Access Compliance Report Public Rights-of-Way (Curb Ramps)

Intersection ID: 21311 Main Street: BURNT MILL RD **Cross Street: NORTHAMPTON DR** Location: NW ADA ID: 265E5E55BB9D Ramp Type: PerpDiag Initial Pass/Fail: Fail **Overall Compliance: No** Severity Score: 33.75

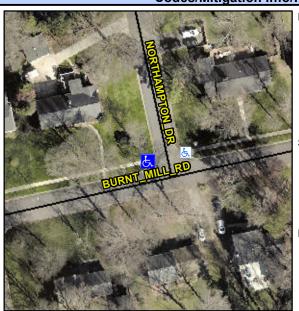
Possible Solutions: Remove & Replace Curb Ramp With Two New Directional Ramps or Equivalent. Surveyor Notes: N/A PROW/ADA: Not Found, R304.5.1, R304.5.3

Field Measurements/Component Compliance					
Compliance Description		Data	Comp	liance Description	Data
N/A	Ramp Length (in)	47.0	Yes	Ramp Slope (%)	5.1
No	Ramp Width (in)	47.5	No	Ramp XSlope (%)	11.2
N/A	Flare Type LT	N/A	N/A	Flare Type RT	N/A
N/A	Flare Slope LT (%)	N/A	N/A	Flare Slope RT (%)	N/A
N/A	Flare Traversable LT?	N/A	N/A	Flare Traversable RT?	N/A
N/A	Landing Length (in)	N/A	N/A	DWS Provided?	N/A
N/A	Landing Width (in)	N/A	N/A	DWS Contrast?	N/A
N/A	Landing Slope (%)	N/A	N/A	DWS Length (in)	N/A
N/A	Landing X Slope (%)	N/A	N/A	DWS Full Width?	N/A
N/A	Landing Curb? (Y/N)	N/A	N/A	DWS Offset (in)	N/A
N/A	Shared Landing?	N/A			
N/A	Gutter Ponding?	N/A	N/A	Gutter Slope (%)	N/A
N/A	Gutter Lip Ht (in)	N/A	N/A	Gutter X Slope (%)	N/A
N/A	Painted X Walk1?	No	N/A	Painted X Walk2?	No
	X Walk 1 Direction	To S		X Walk 2 Direction	To E
N/A	X Walk 1 Width (in)	N/A	N/A	X Walk 2 Width (in)	N/A
	X Walk 1 Slope (%)	3.2		X Walk 2 Slope (%)	11.6

X Walk 1 X Slope (%)	13.5		X Walk 2 X Slope (%)	1.3
N/A	Ramp inside XWalk1?	N/A	N/A	Ramp inside XWalk2?	N/A
	Road Slope (%)	9.0	N/A	Clear Space?	N/A
	Road X Slope (%)	9.3	N/A	Clear Space to XWalk (in)	N/A
N/A	Any Obstructions?	N/A	N/A	Storm Grate/Utility Hazard?	N/A
	Obstruction Type			Storm Grate/Utility Type	
		N/A			N/A
			Yes	Surface Condition? (G/P)	Good
